D060145-A

PLEASE NOTE D050444 IS SHOWN.  
FOLLOW INSTRUCTIONS ON REPLACEMENT  
SHEET FOR D050444.

UNLESS OTHERWISE SPECIFIED DIMENSIONS ARE IN INCHES		DATE	NAME	PARTS LIST	
DRAWN	2-16-96	KEM	LIGO CALIFORNIA INSTITUTE OF TECHNOLOGY MASSACHUSETTS INSTITUTE OF TECHNOLOGY		
CHECKED			SYSTEM	LHD /LLO	
			SUB-SYSTEM	TCS	
			NEXT ASSY	NONE	
			PART NAME	QUAD SUS FIXTURE ASSEMBLY	
			SIZE	DWG. NO.	REV
			D	D060145-A	
			SCALE:	SHEET 1 OF 2

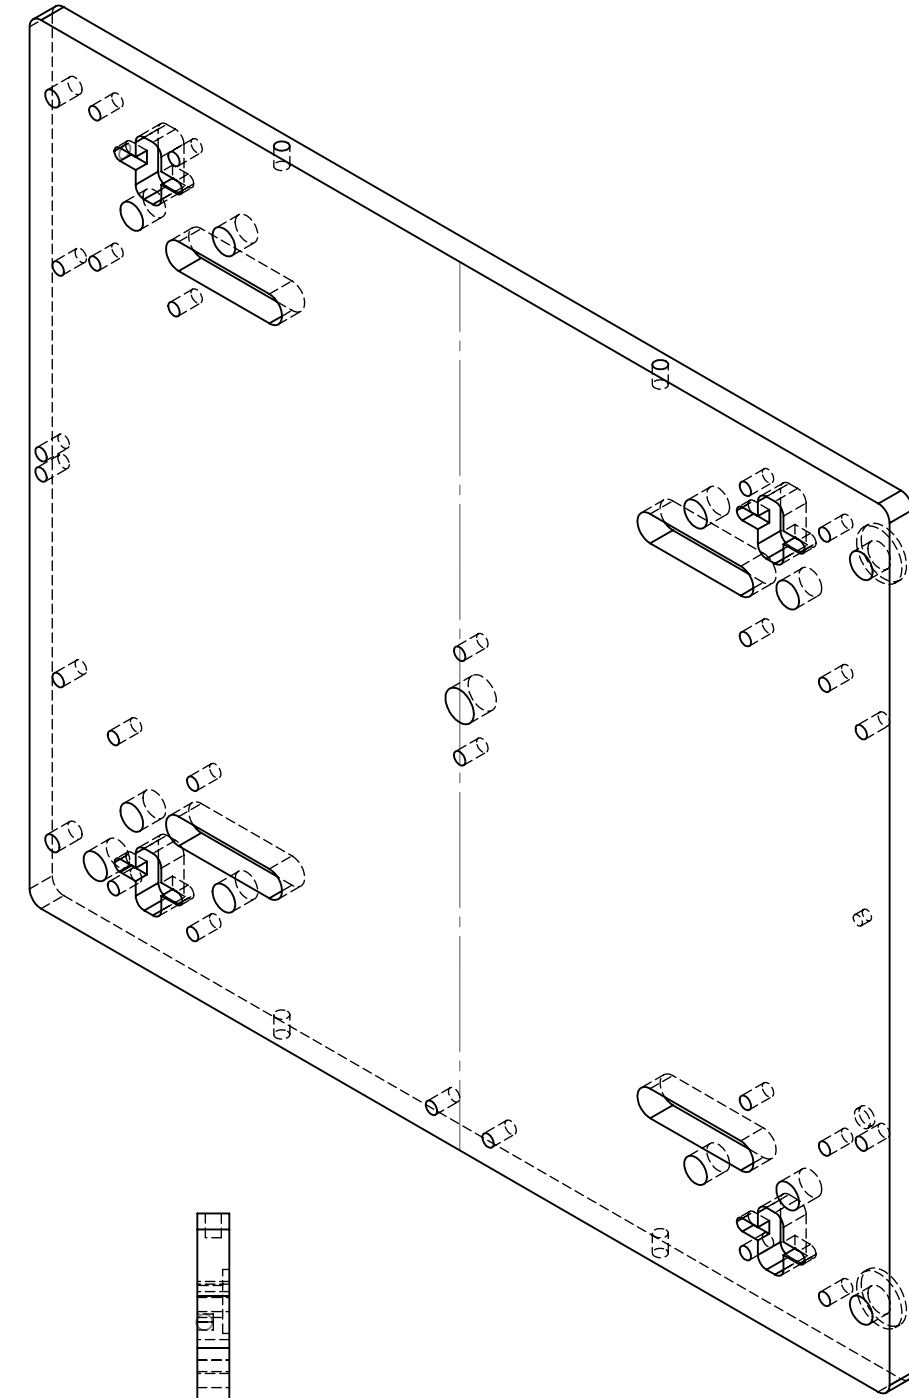
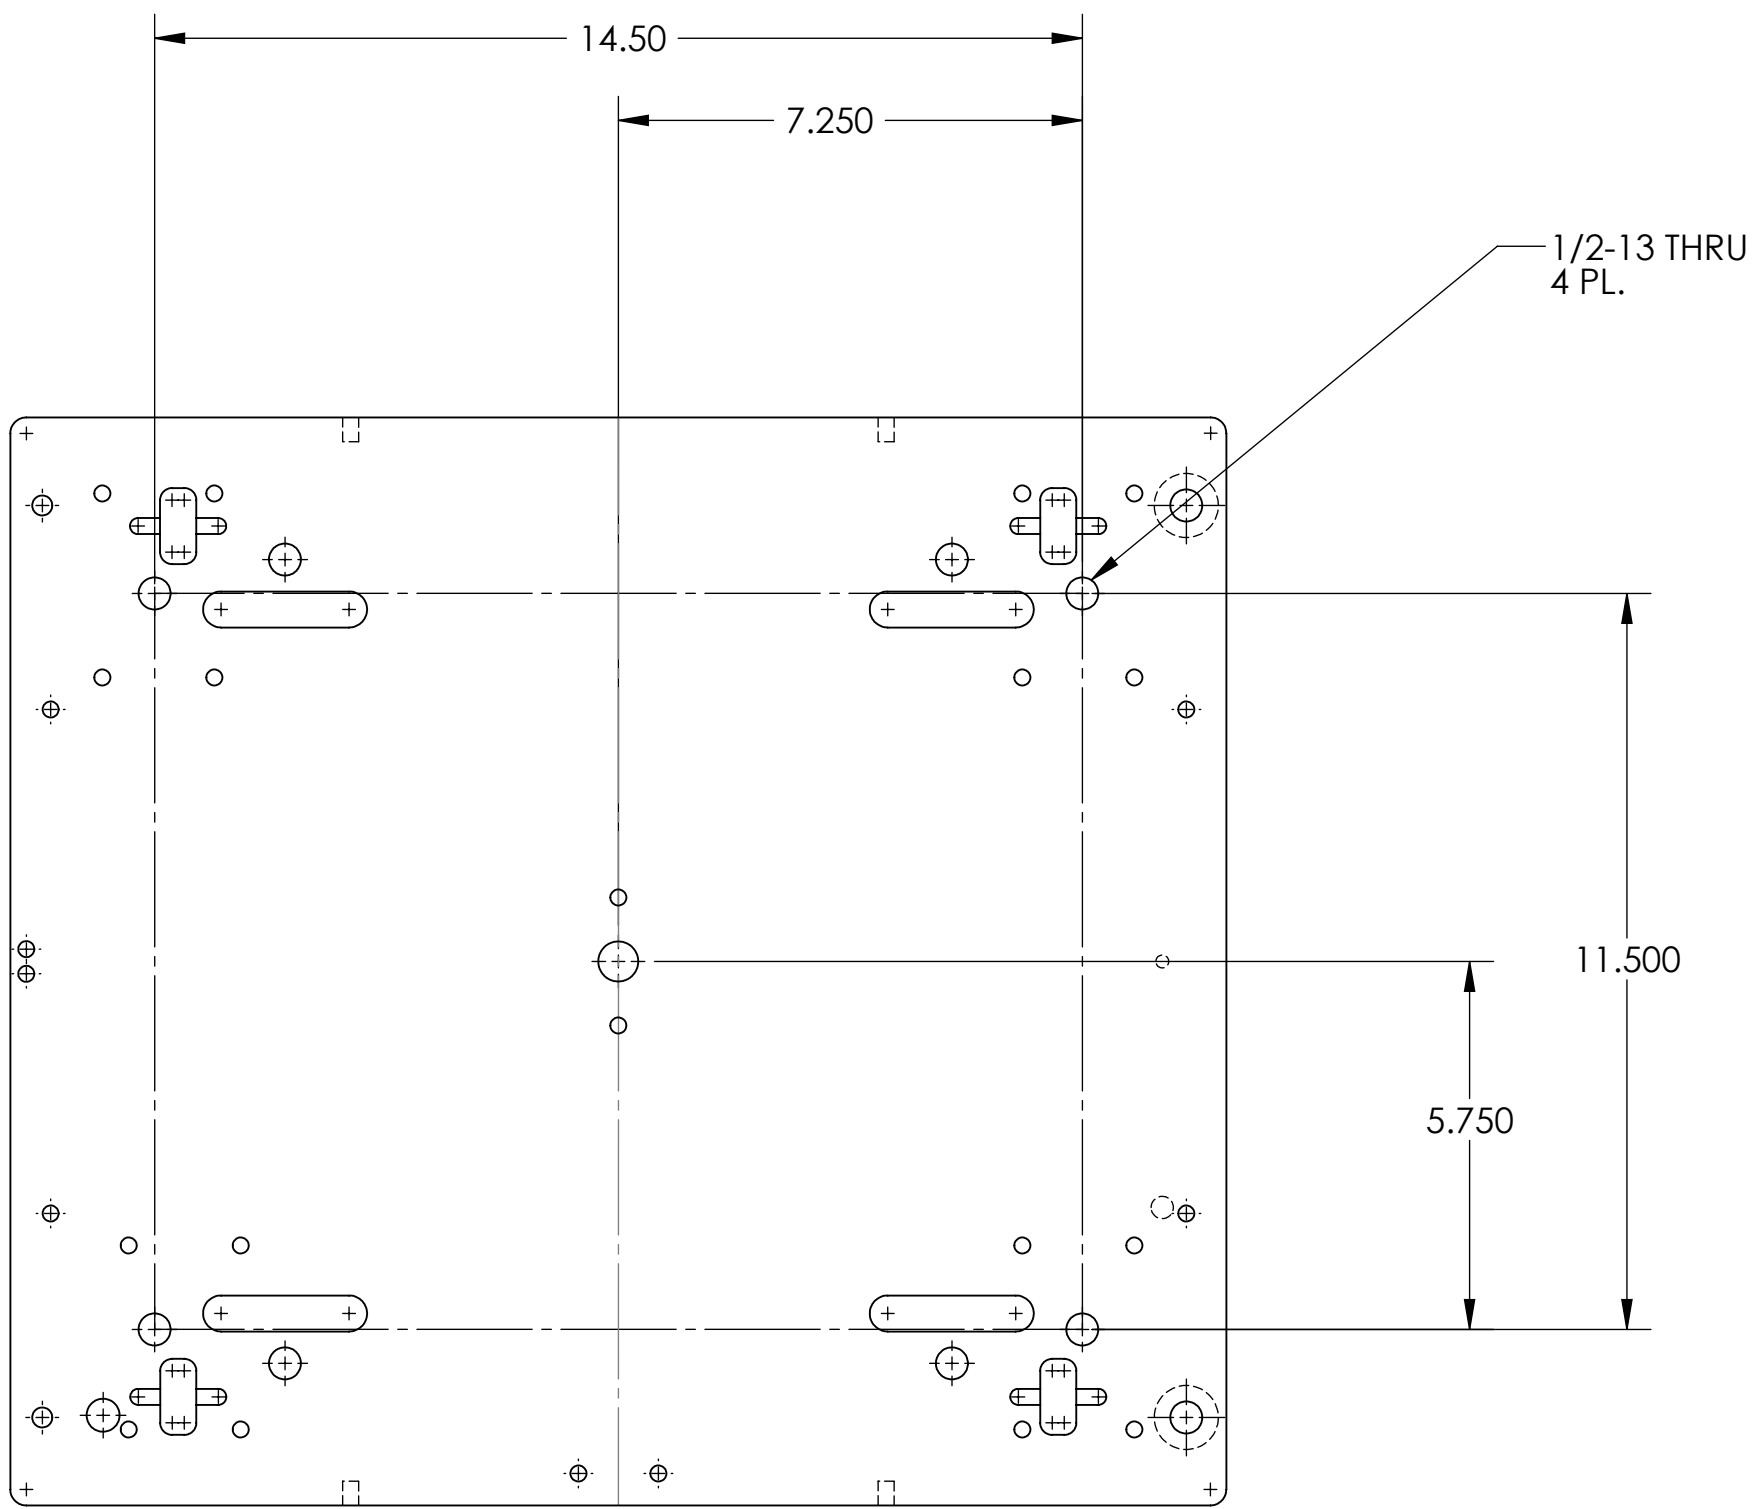
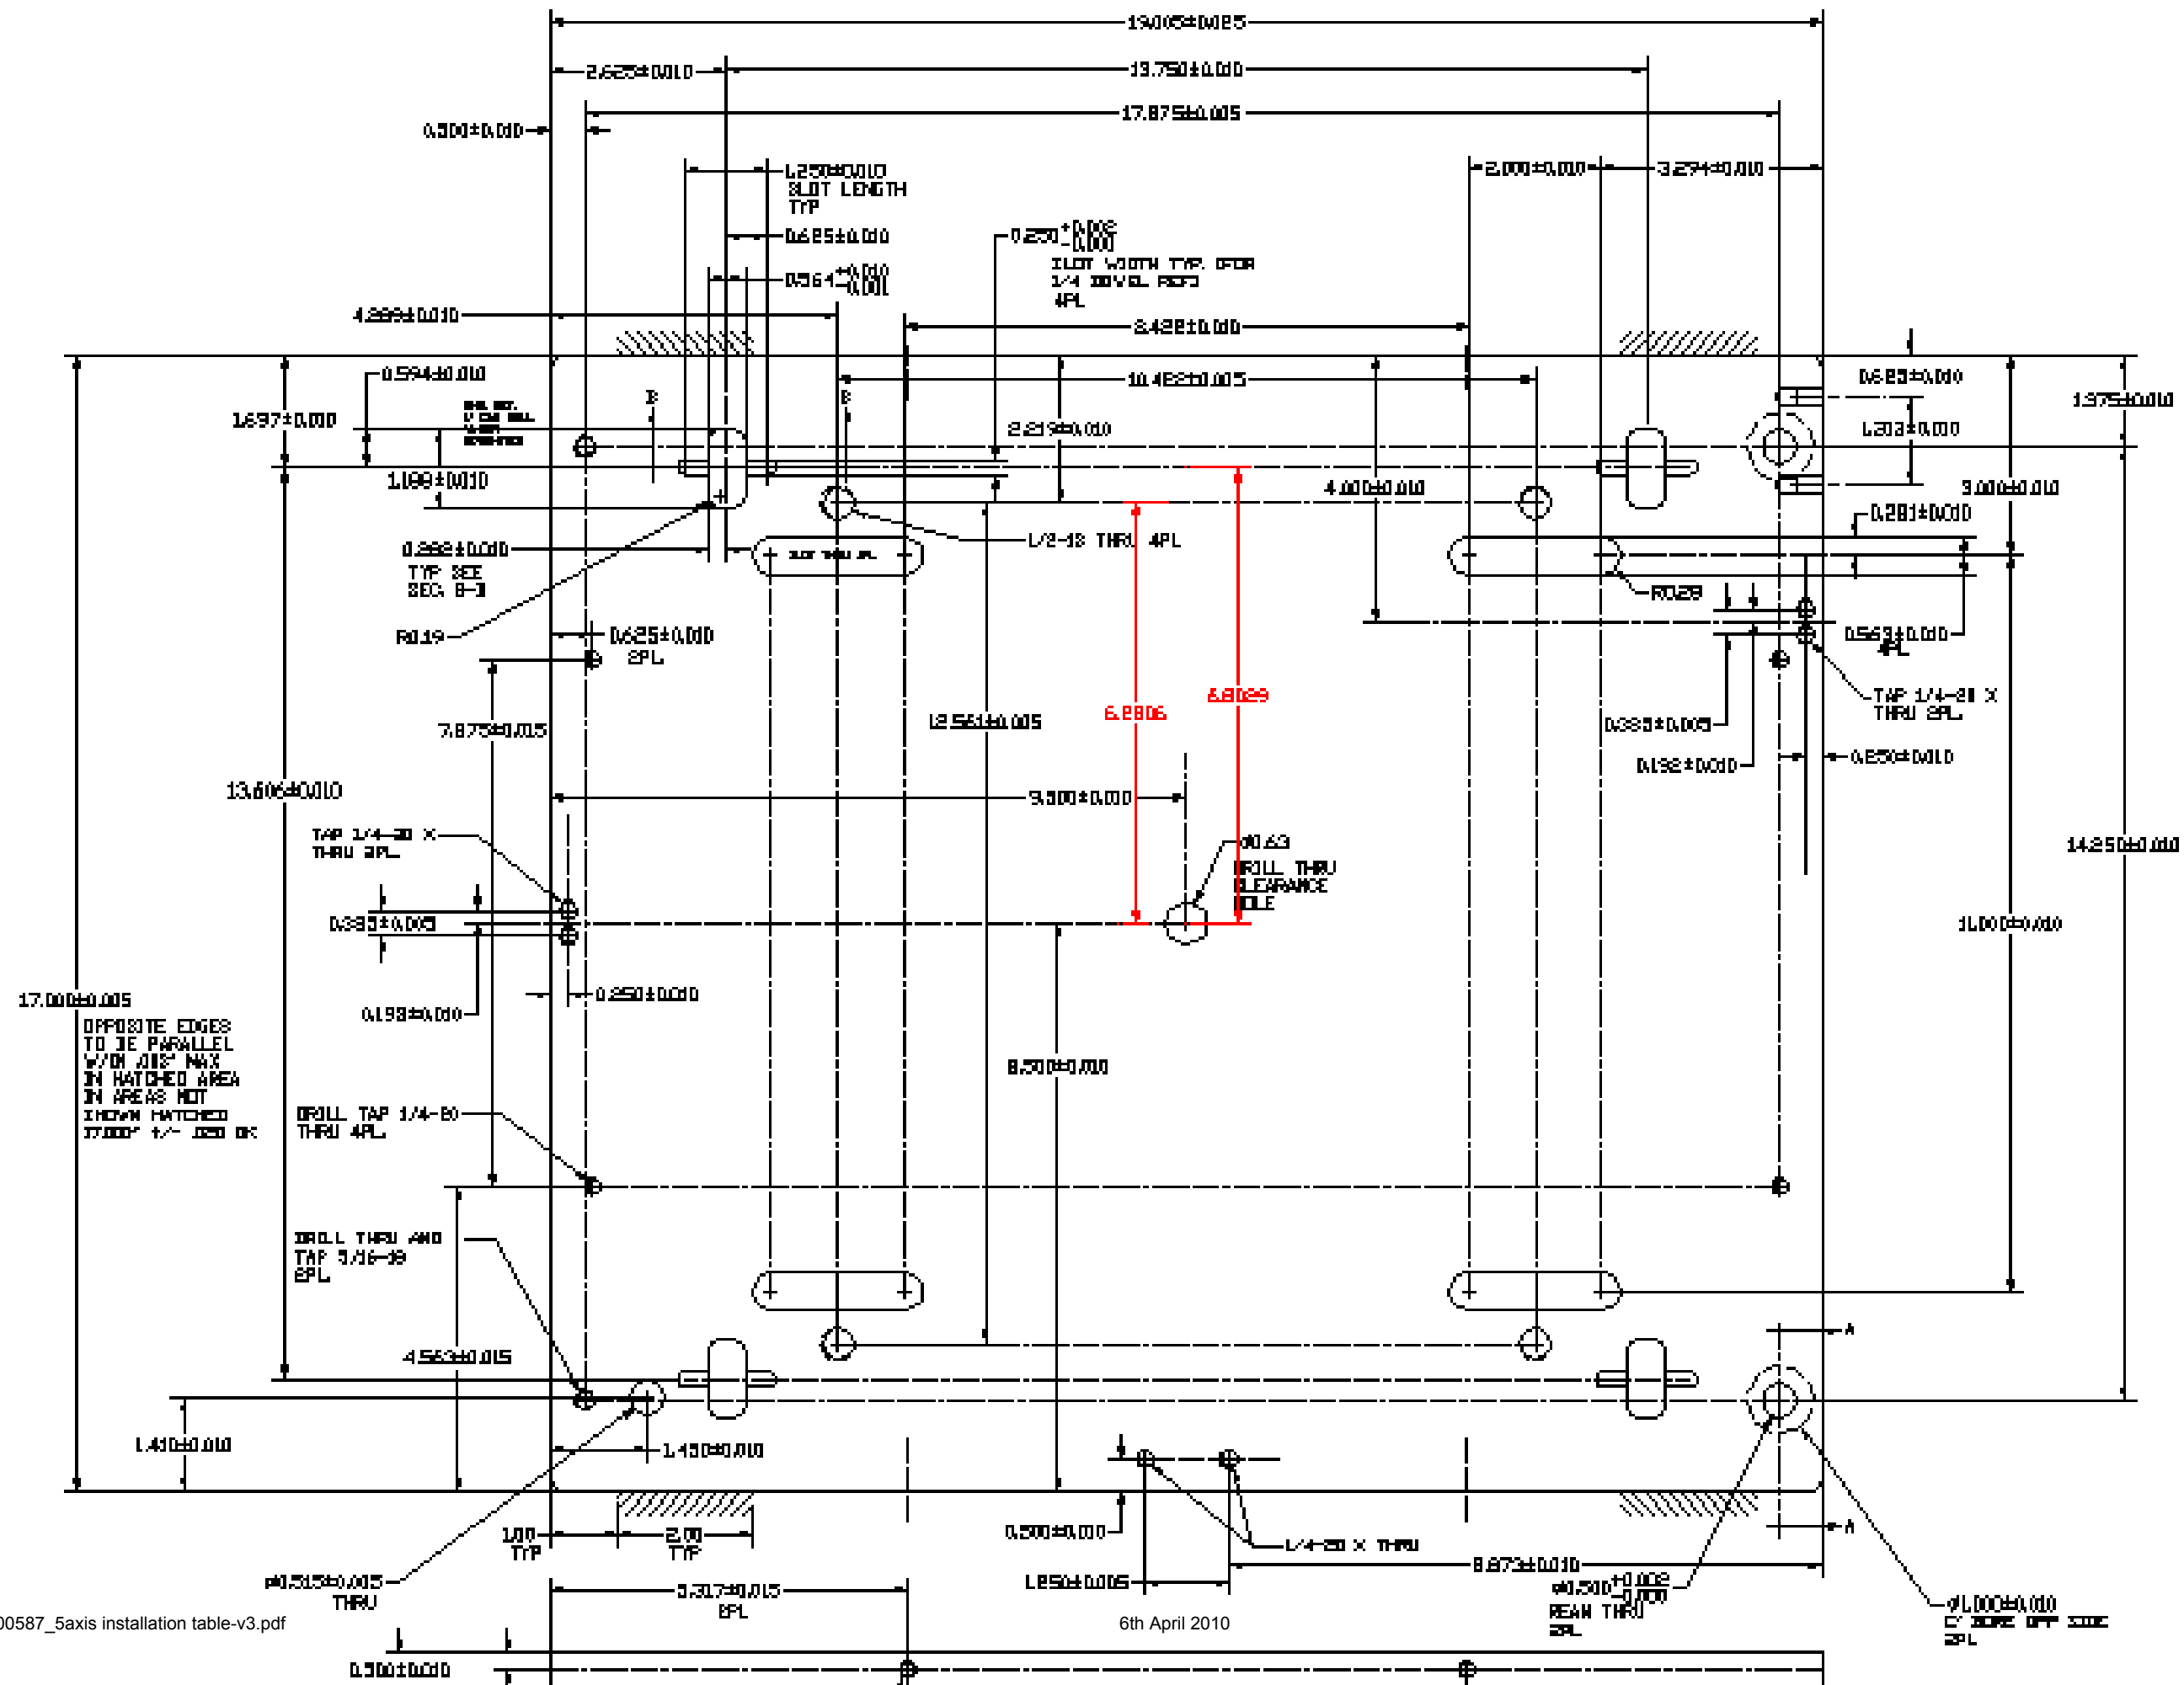
MODIFY EXISTING PLATE

THIS IS A MISSING DIMENSIONS CLARIFIED FOR D050446-A.

THIS IS ALSO A MISSING DIMENSIONS CLARIFIED FOR D050446-A.

SYSTEM	LIGO	CALIFORNIA INSTITUTE OF TECHNOLOGY
LASTI		MASSACHUSETTS INSTITUTE OF TECHNOLOGY
SUB-SYSTEM	QUAD SUSPENSION	
NEXT ASSY	D06045-A	
PART NAME	ROLL PLATE, QUAD INSTALL FIXTURE	
SIZE	DWG. NO.	REV
E	D050444-A	
SCALE:		SHEET 1 OF 1

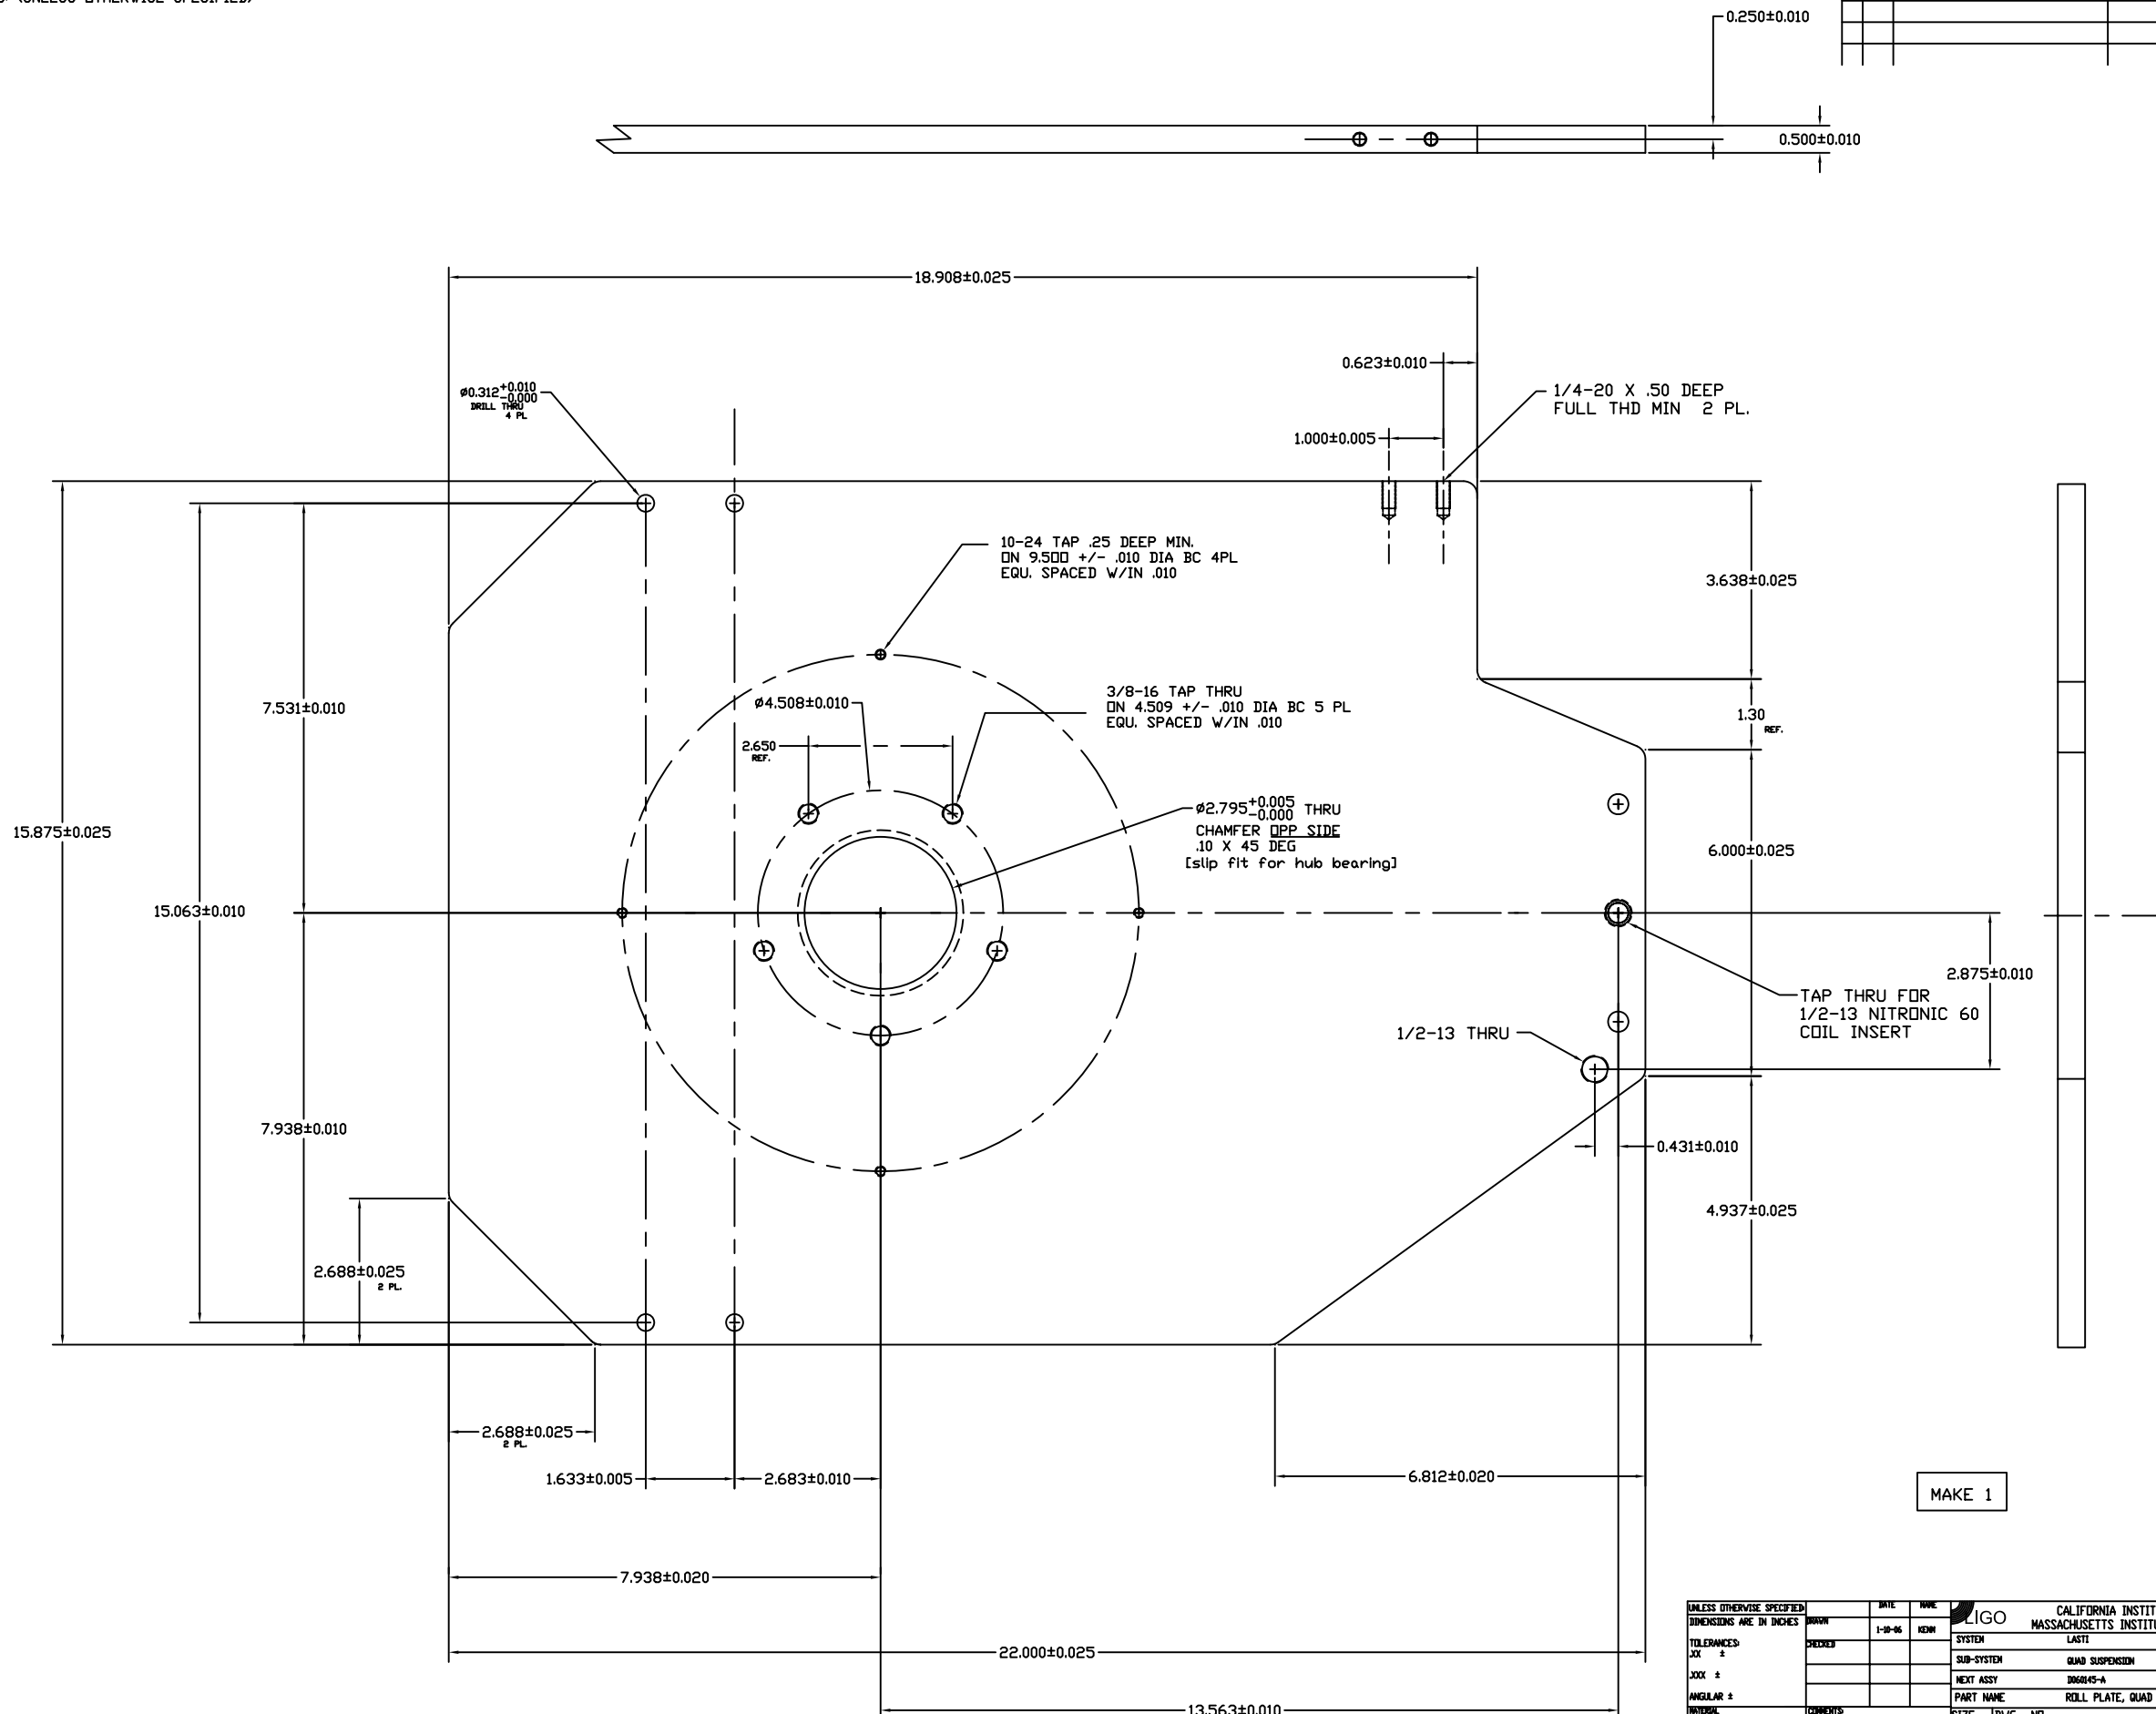
DRAWING D050444-A HAS BEEN REMOVED.

INSTEAD OF MAKING D050444-A AS SHOWN IN THE BILL OF MATERIALS PLEASE MAKE A SECOND COPY OF D050446-A (INCLUDING THE REVISION).
